**RE: Rutledge Office/Warehouse  
9721 Rutledge Rd NE  
Grading Plans and Drainage Report  
Engineer's Stamp Date: 03/07/22  
Hydrology File: D17D003AA7**

Based upon the information provided in your submittal received 12/17/2021, the Grading Plans and Drainage Report are approved for Building Permit, Grading Permit, and for action by the DRB on Platting and Site Plan for Building Permit. Please attach a copy of this approved plan in the construction sets for Building Permit processing along with a copy of this letter.

DRAINAGE REPORT

**RUTLEDGE OFFICE/WAREHOUSE DEVELOPMENT  
9721 RUTLEDGE ROAD, NE  
ALBUQUERQUE, NEW MEXICO**

RONALD R. BOHANNAN P.E. #7868	RUTLEDGE OFFICE/WAREHOUSE ALBUQUERQUE, NM	DRAWN BY pm
	RUTLEDGE SPEC BUILDING GRADING AND DRAINAGE PLAN	DATE 3-7-22
	 TIERRA WEST, LLC 5571 MIDWAY PARK BL NE ALBUQUERQUE, NEW MEXICO 87109 (505) 858-3100 www.tierrawestllc.com	DRAWING
		SHEET # <b>GR-1</b>
		JOB # 2021051

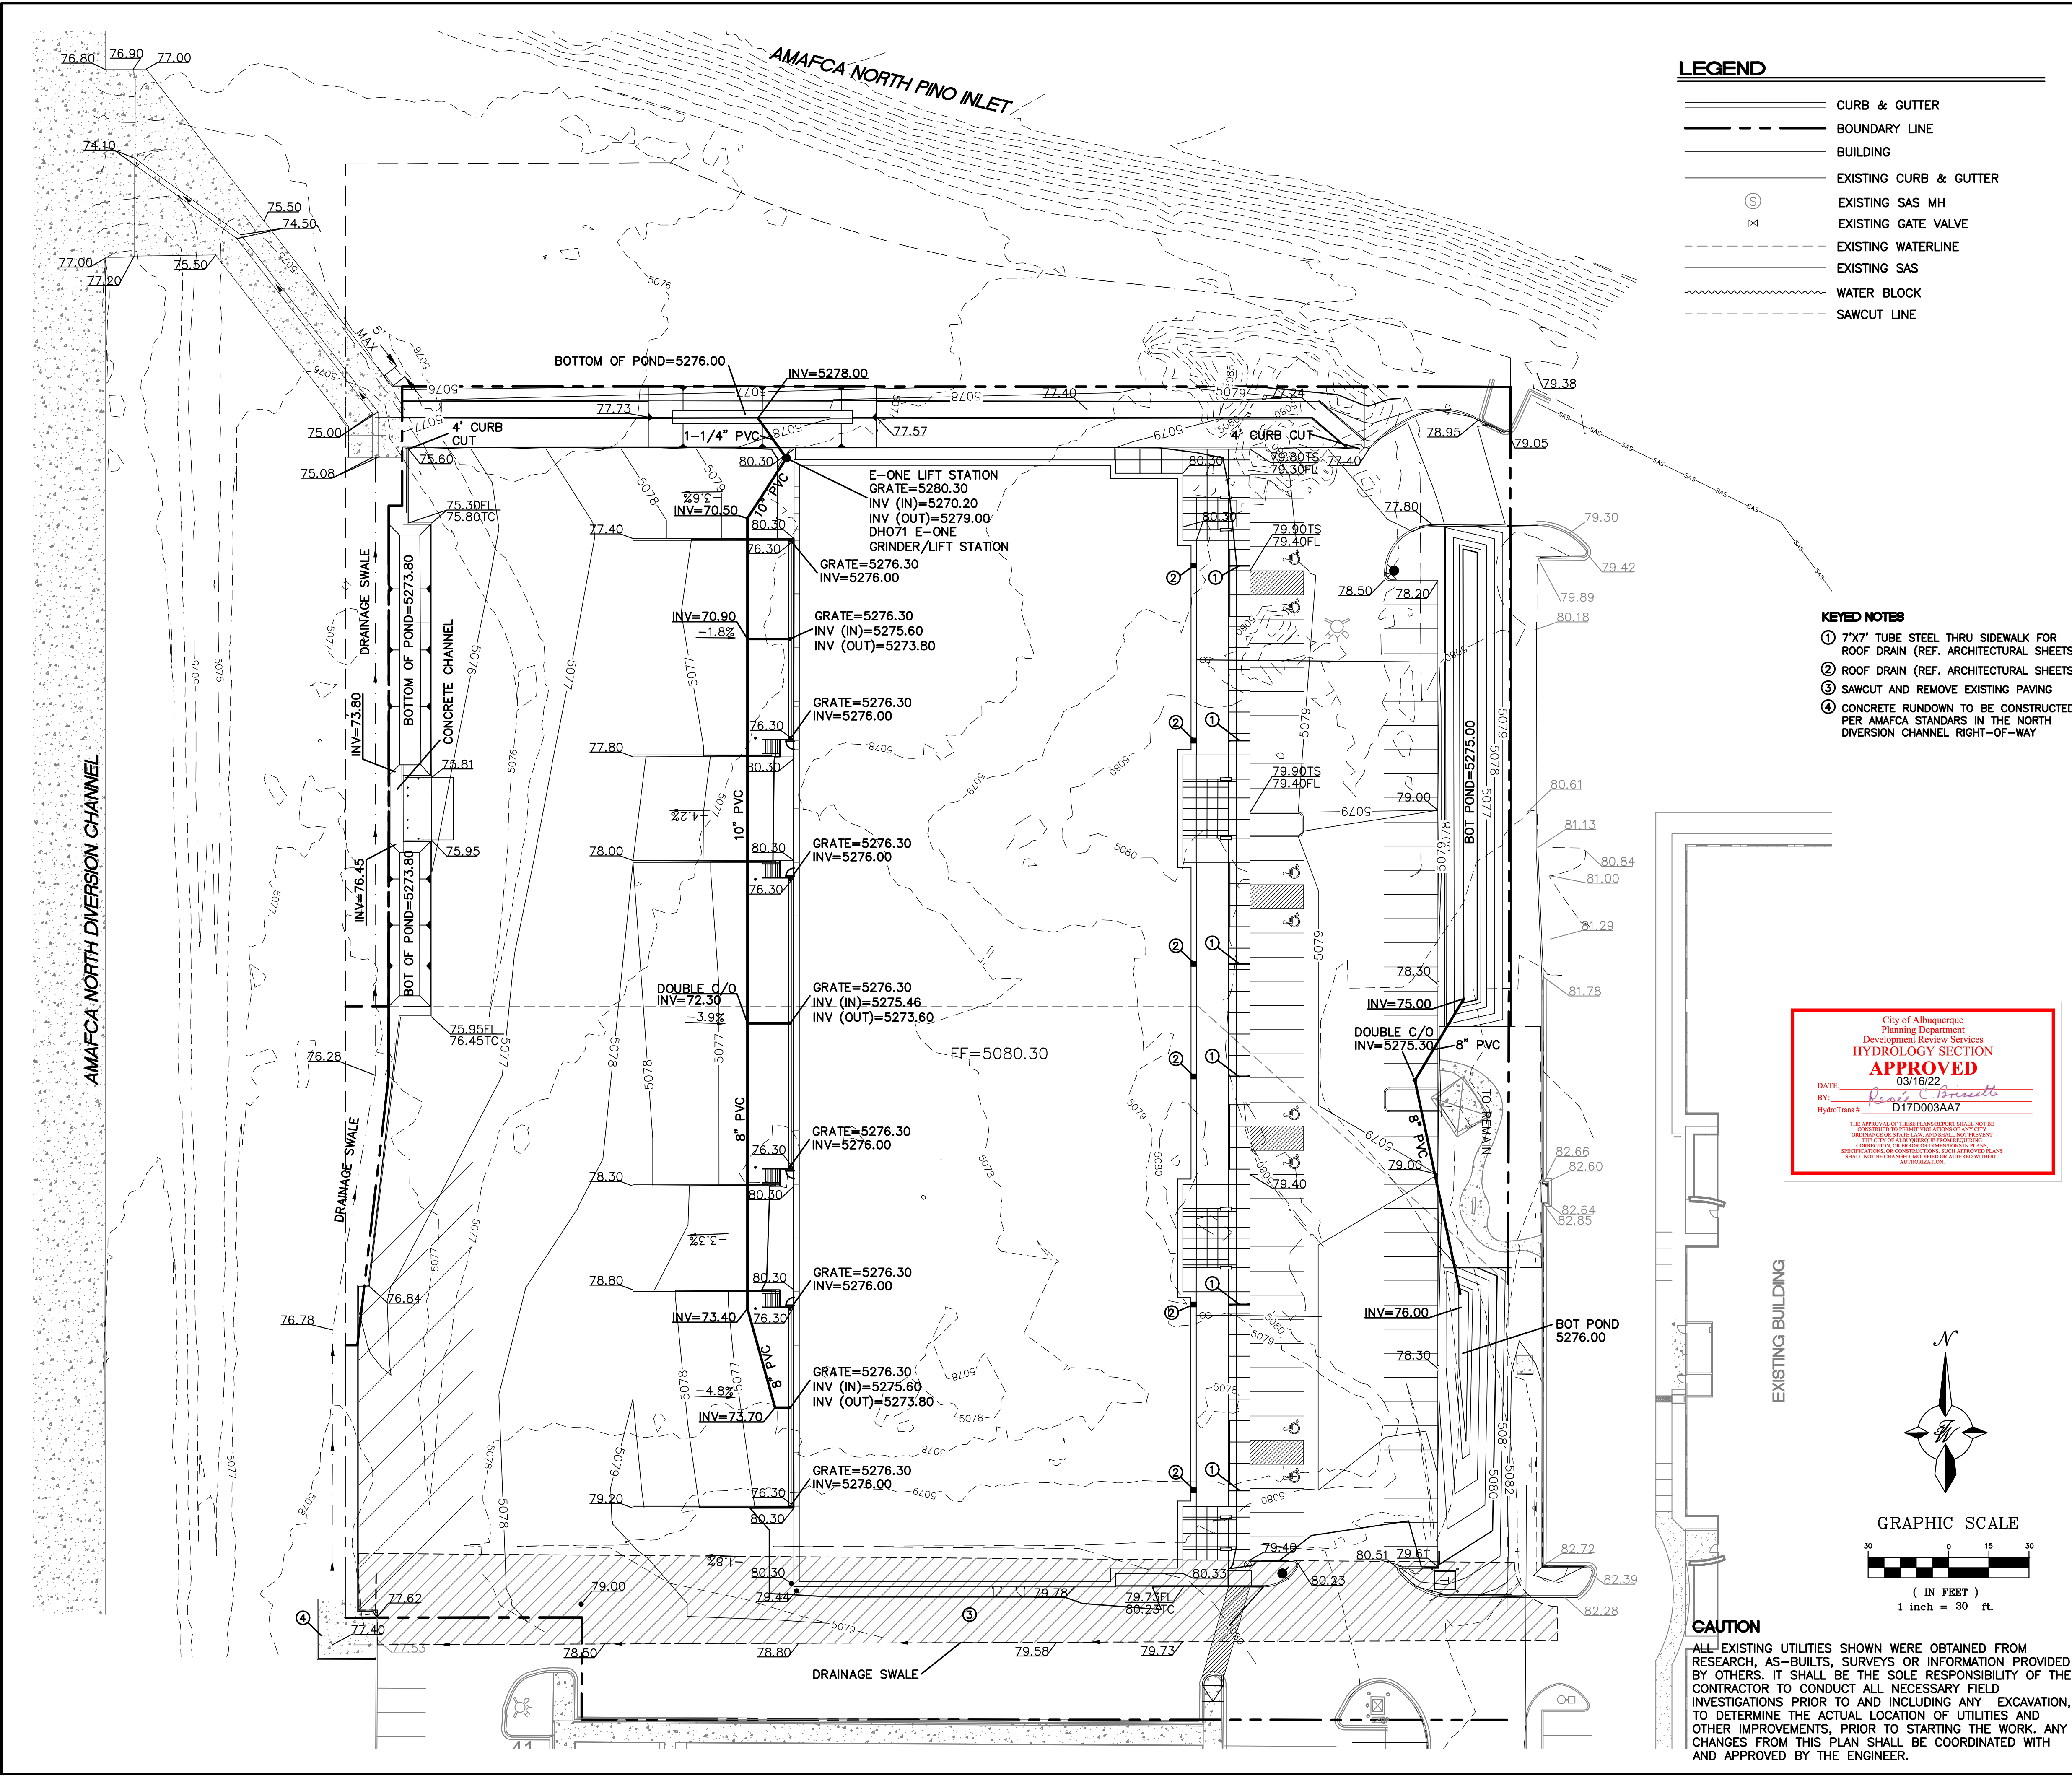
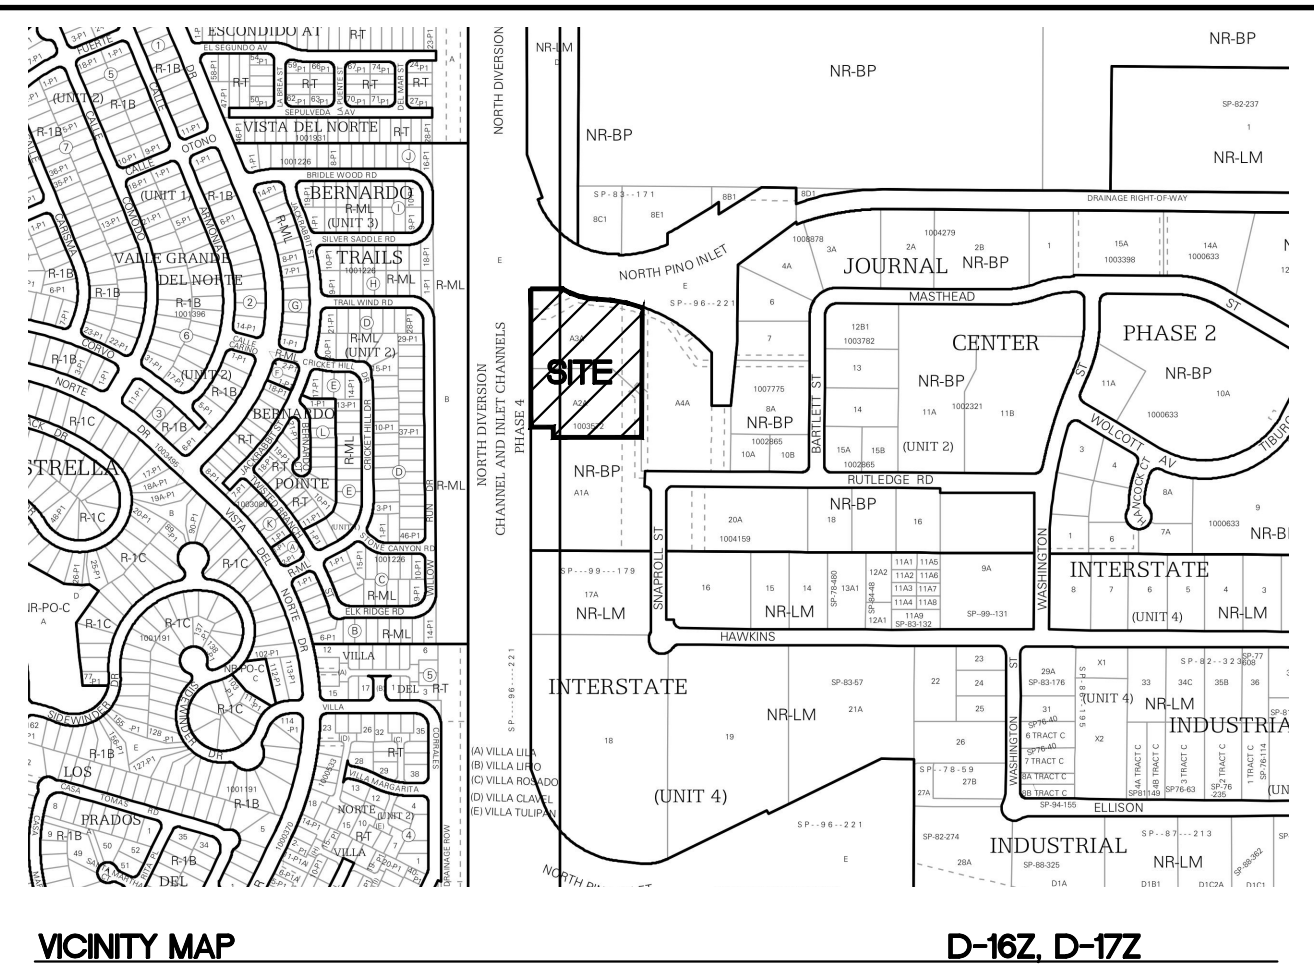
1. Engineer's Certification, per the DPM Part 6-14 (F): *Engineer's Certification Checklist For Non-Subdivision* is required.
2. AMAFCA is requiring a Maintenance and Encroachment License for maintenance of the swale and concrete rundown in the AMAFCA NDC ROW. This must be executed and recorded with the County. Hydrology will need email confirmation of this from AMAFCA.
